Proposal by T&E on how to address vehicle-forced speed errors

Version: 28-6-2017

Problem description

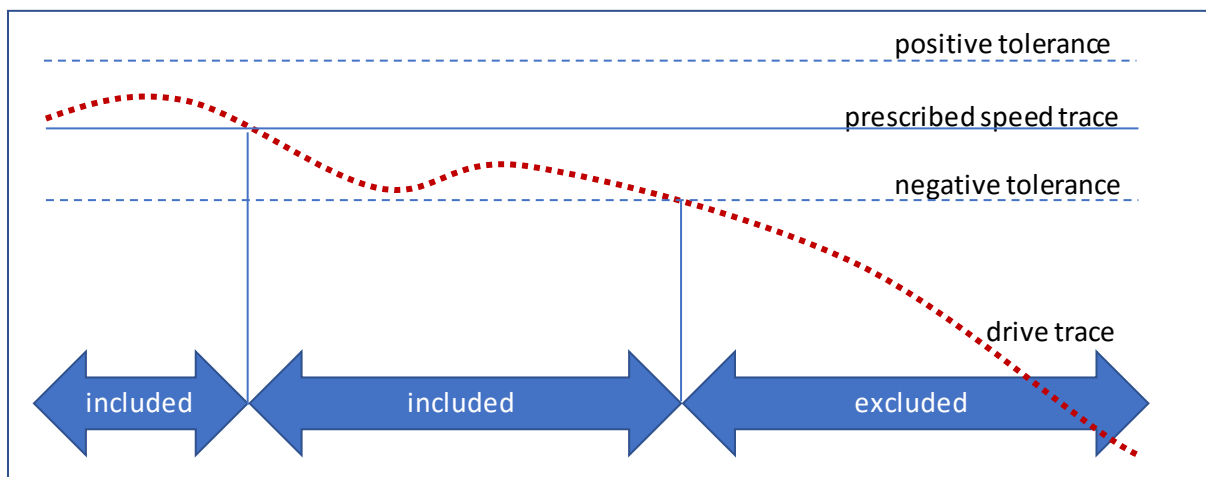
Vehicle-forced errors should not be included into the calculation of the DTI, only errors related to the driving behaviour of the test driver. As soon as the vehicle exceeds the drive trace tolerance to the negative side (lower speed), this is to be considered a vehicle-forced error and the remaining part of the test cycle is excluded from the DTI calculation. This is illustrated by the figure below, which shows the second constant speed segment in the shortened test procedure.

Note that the part which is below the prescribed speed trace, but still above the negative tolerance should be *included* in the DTI calculation.

For this case of the shortened test procedure, the driver is instructed to stop the vehicle so the drive trace will not re-enter within the allowed tolerance. It is proposed to make a requirement that the DTI calculation will be done up until the point where the drive trace falls below the lower tolerance (with reference to Annex 6, par. 2.6.8.3) just prior to reaching the break-off criterion (with reference to Annex 8, par. 3.4.4.2.3.).

The part which is below the prescribed speed trace, but still above the negative tolerance (middle section in the first figure) should be included in the DTI calculation because the test driver could anticipate that the REESS depletion is upcoming, and aim to drive in this region to positively influence the result.

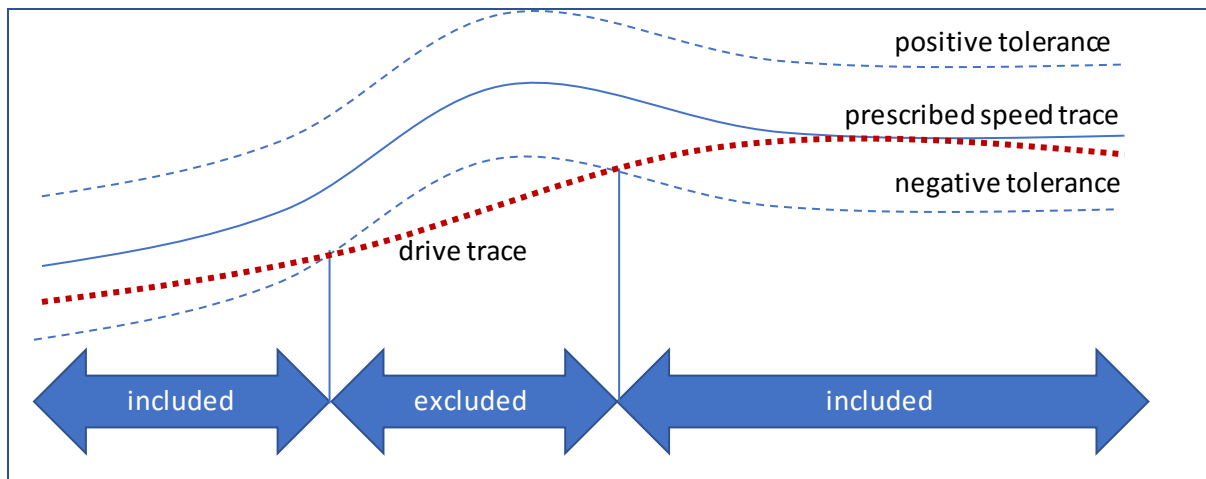
The other possible scenario is for a vehicle that is not capable to accurately follow the prescribed cycle, e.g. because the nearly depleted REESS reduces the acceleration power. This is illustrated in the figure below .

Note that the part where the drive trace is re-entering the allowed speed tolerance should be *included* in the DTI calculation.

For this case the driver is instructed according to par. 2.6.8.3 of Annex 6 to fully activate the accelerator control during the time that the drive trace is below the negative tolerance. That will ensure that this period does not take more time than needed, and the speed deviation is strictly vehicle-forced. It is proposed to make a requirement that the DTI calculation will exclude the period where the drive trace falls below the negative tolerance (with reference to Annex 6, par. 2.6.8.3), up until the point where it again reaches the negative tolerance.

For the case of the second figure, the part where the prescribed speed trace re-enters within the drive trace tolerance area should be included into the DTI calculation, because the test driver could take advantage of this by continuing to drive just below the speed trace.
